EXTRA INFORMATION REQUESTED BY COUNCIL

**CHANGE OF USE TO EXIST. INDUSTRIAL BLDG INTO A VEHICLE SMASH & MECH. WORKSHOP.**  
project  
**102**  
BENAROON ROAD  
LAKEMBA 2195  
address

**SITE PLAN & SITE ANALYSIS PLAN**  
drawing  
**323-132**  
project  
**A01**  
drawing no.  
**B**  
issue  
29/9/23

SITE PLAN 1:200

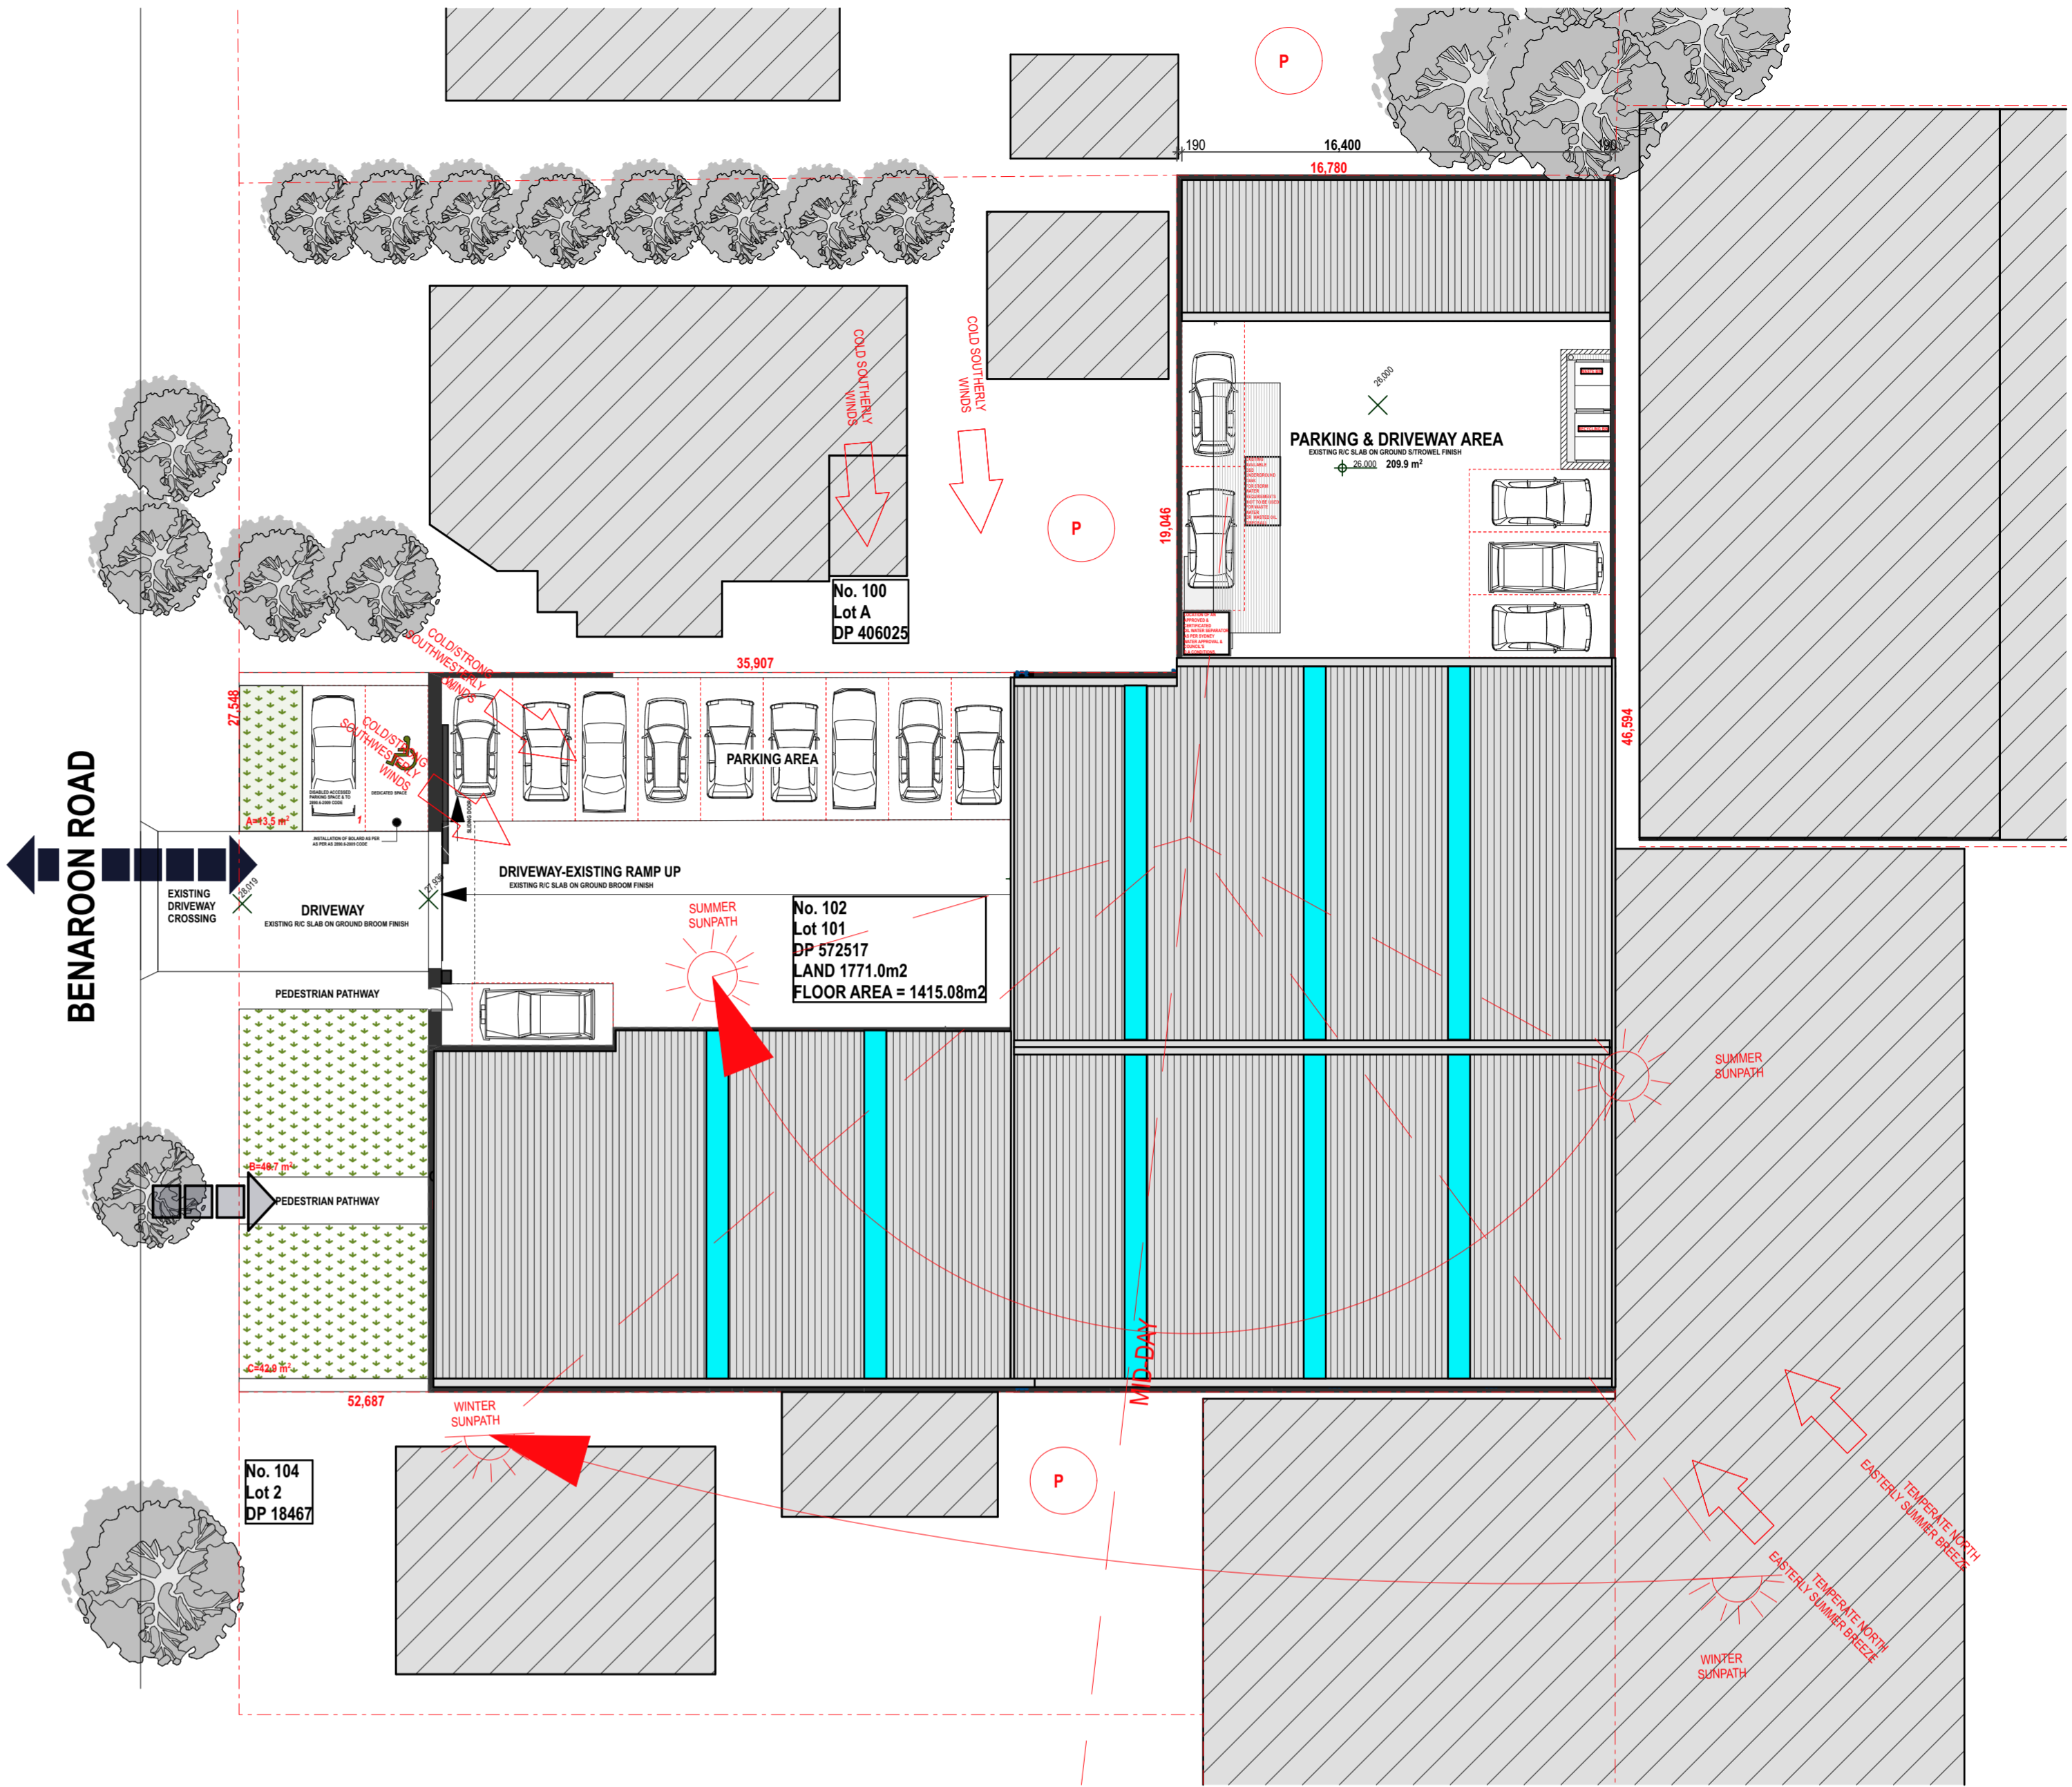
Working bay B and D are obstructed by parking space 27, 26 and vehicle repair working bay number E. This is to be resolved in amended plans.	Plans have been altered accordingly.
Furthermore, it is not clear how loading and unloading will happen within the site and how forward entry and exit is feasible for the loading truck. You are required to submit a swept path analysis demonstrating feasibility.	Plans have been altered accordingly.
